# ADMINISTRATIVE DETERMINATION & CERTIFICATION

## FINAL PLAT

Menard's Addition

**PF-14-00201:** Consider a Final Plat for Menard's Addition, a 7 lot commercial subdivision, located at 1900 W 31<sup>st</sup> St. & 1200 W 31<sup>st</sup> St. Submitted by Menard, Inc. property owner of record.

#### MASTER STREET TREE PLAN

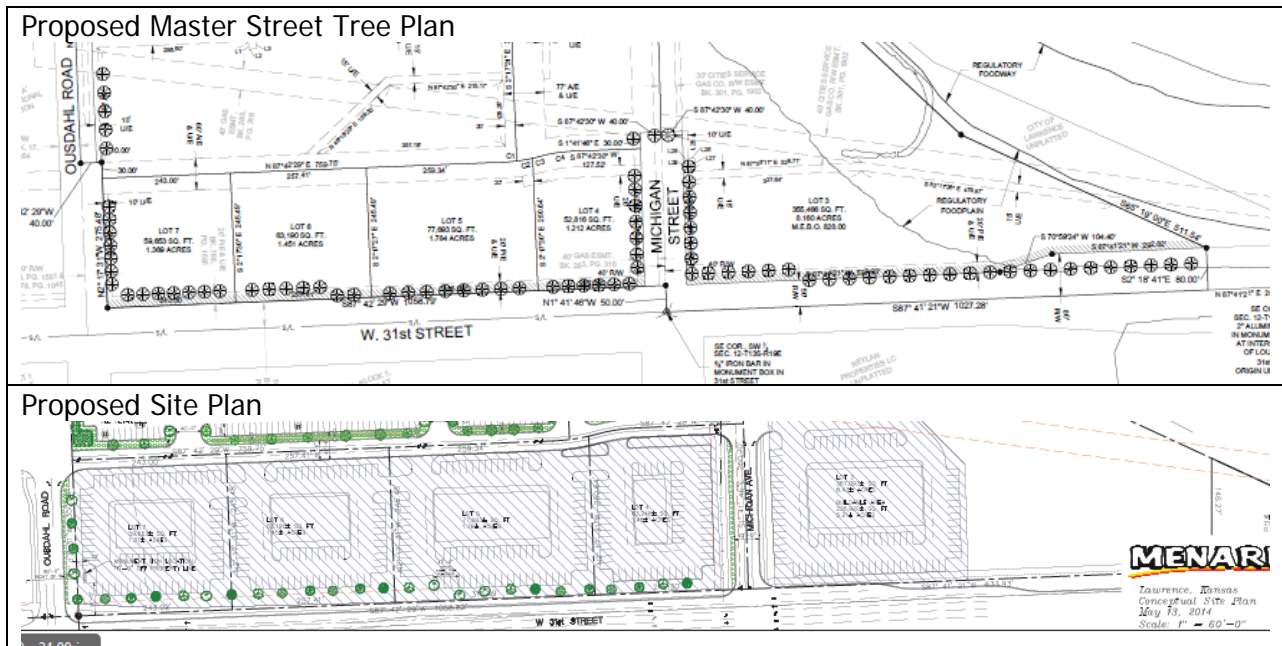
The applicant has submitted a Master Street Tree Plan consistent with the requirements of the Subdivision Regulations. Minor revisions were noted during the review process regarding tree placement and utility conflicts. Additional field assessment will be needed to assure adequate separation of street trees from underground utility lines and to assure sight distance at intersections is maintained.
